01 Floor plans

Level 01 Floor Plan

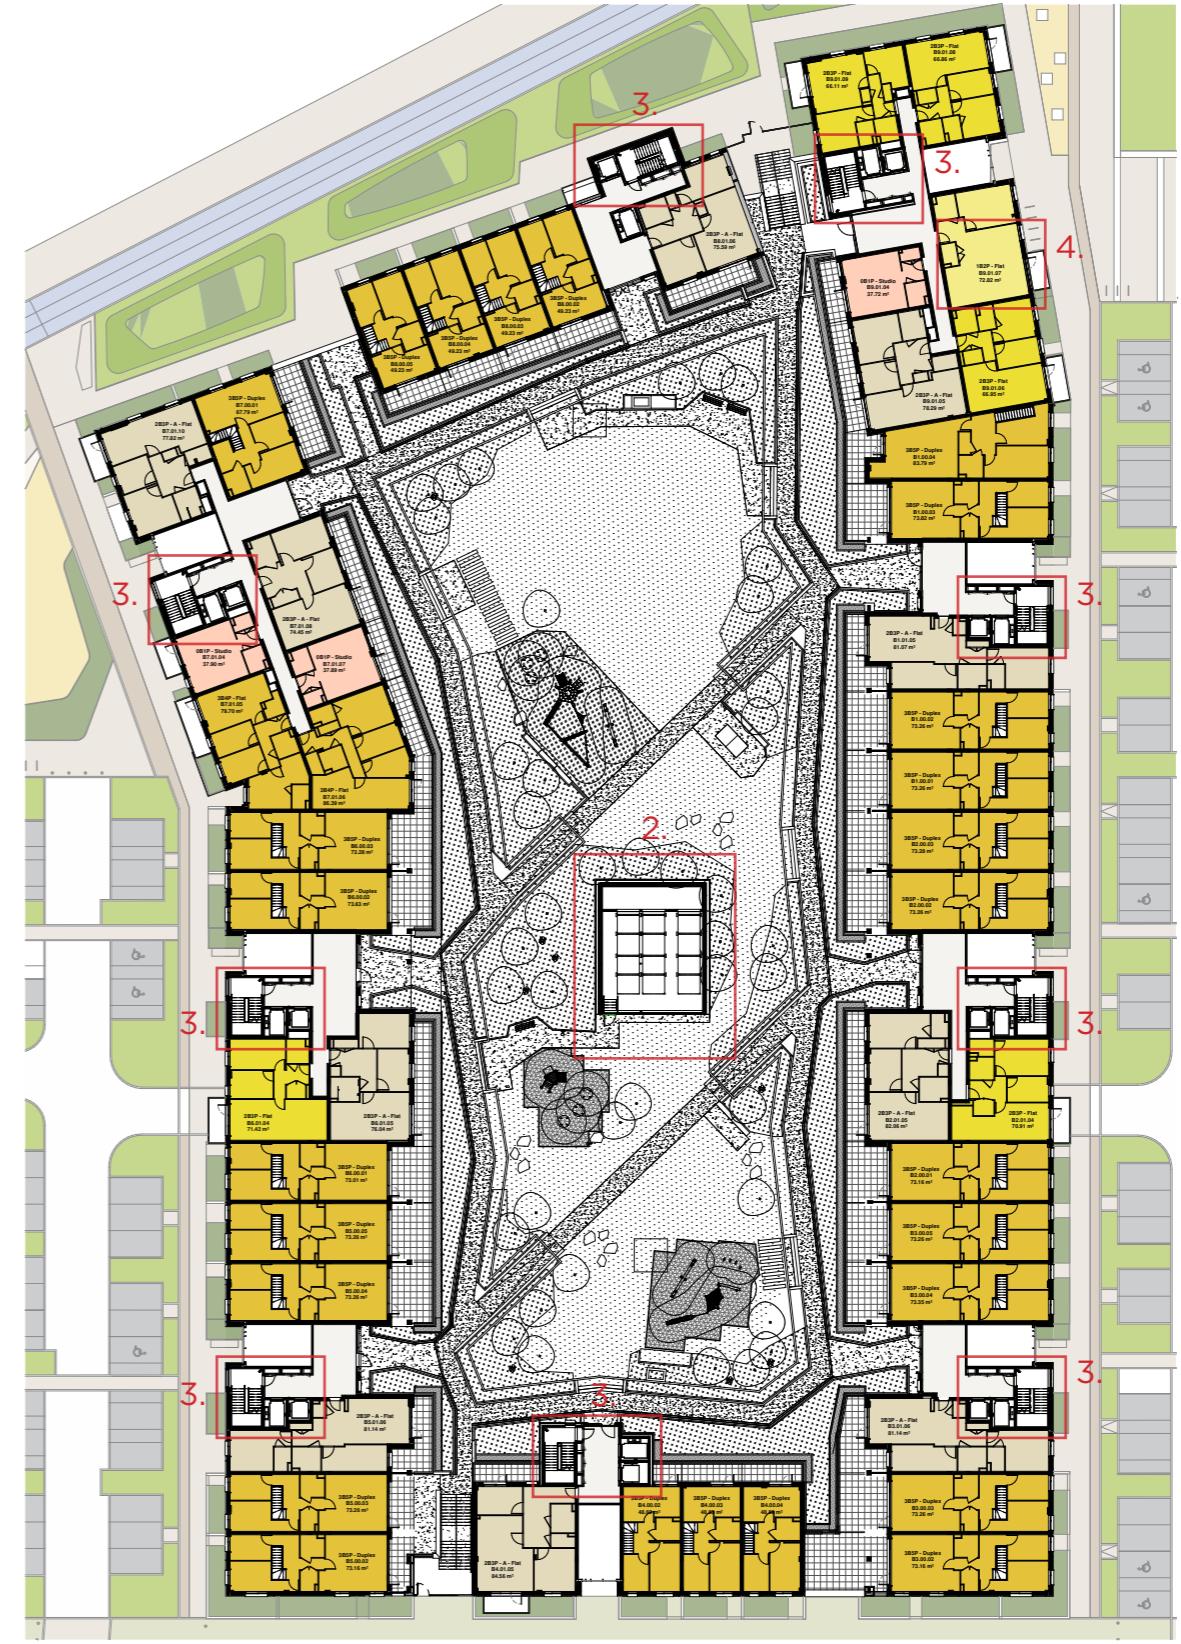
- Omission of podium entrance canopies; security risk to adjacent apartments at first floor.
- Addition of plant housing for car park smoke extract fans as per developed fire strategy

- Updated core layout as per developed fire strategy; evacuation lifts added to Blocks 4 and 8.
- Reconfiguration of apartment layout. Overall mix remains as consented.
